From: Li, Xunyong
Sent: Monday, 8 March 2021 2:37 AM
To: AC, EPD Customer Services
Cc: TCCS_PC DACOORD; Henriquez, Jose
Subject: COMM-TCCS-202038102-7/249 GUNGAHLIN-01

DEVELOPMENT APPLICATION NO: 202038102

PROPOSAL FOR MULTI UNIT DEVELOPMENT – construction of 99 dwellings (made up of 70 townhouses and 29 apartments) in seven buildings up to 3 storeys in height, with associated basement parking, landscaping and offsite works.

BLOCK: 7	SECTION: 249	SUBURB: GUNGAHLIN
-----------------	---------------------	--------------------------

Image 1

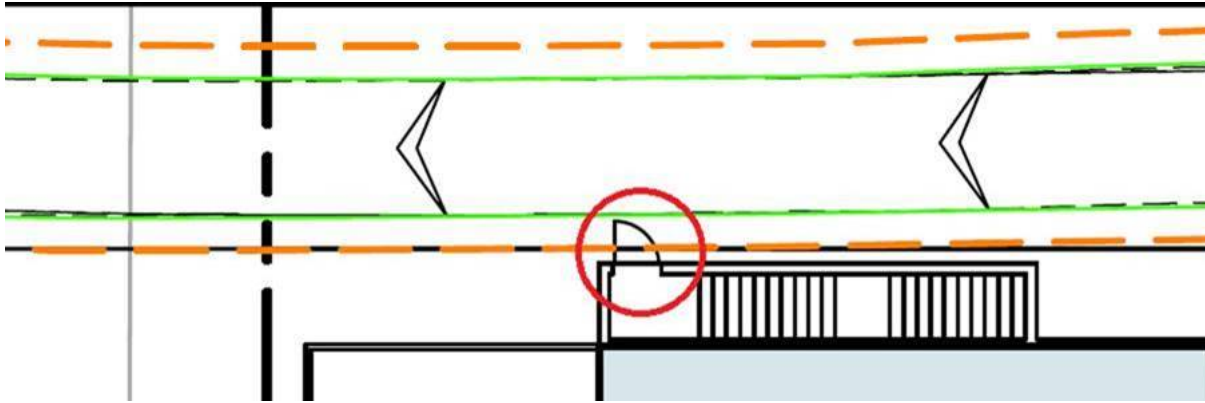
9. Vehicle Turning Paths Plan (TP2201 Rev C).
- It appears that 0.6m clearance for the waste truck movements is adopted within the development. It is only acceptable when driving in straight line. Referring to A7.2 of 2019 Waste Code, if the collection vehicle swept path is constrained by one or more vertical obstructions (i.e. pinch points), the minimum horizontal clearance from the edge of the side mirror(s) of the vehicle to the obstruction(s) must be at least 1.0m.

- The safety clearance intersects with a door and a building (see Image 1 below). This is not permitted.
 - The westbound waste truck template moving into the development needs to be provided.

Image 1

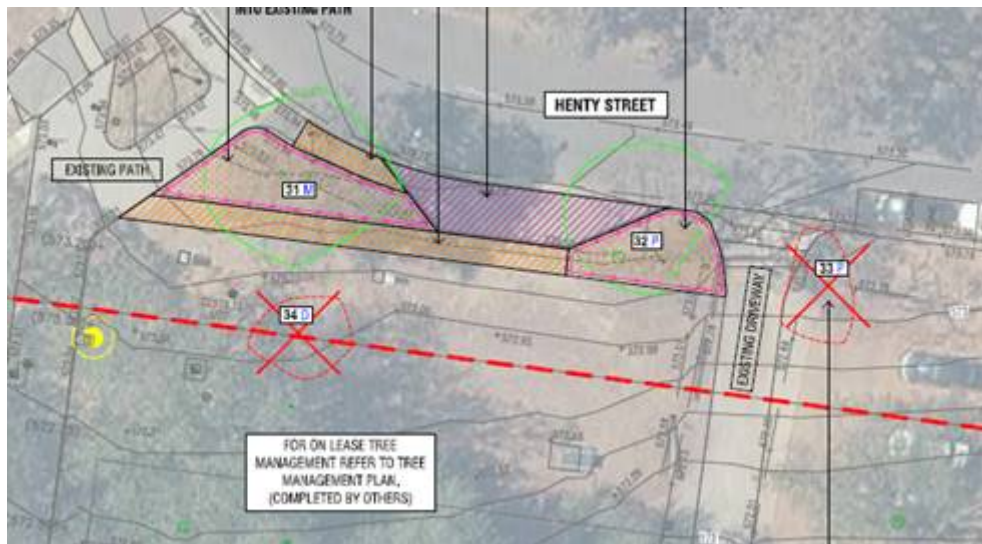
11. As this a commercial development all waste must be stored, transferred and collected on side through domestic vehicles such as utility as it is only a domestic verge crossing from the road to the block.

Figure 4.2 — Examples of accessible parallel parking without kerb extensions

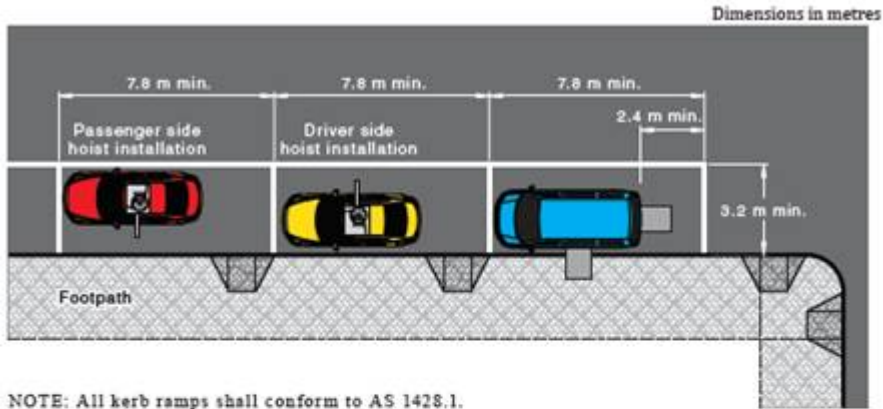
10. A Traffic Control Device (TCD) plan must be provided at the Design Review stage to include the loading and disable parking bays including all line marking and sign posting in accordance with TCCS requirements.
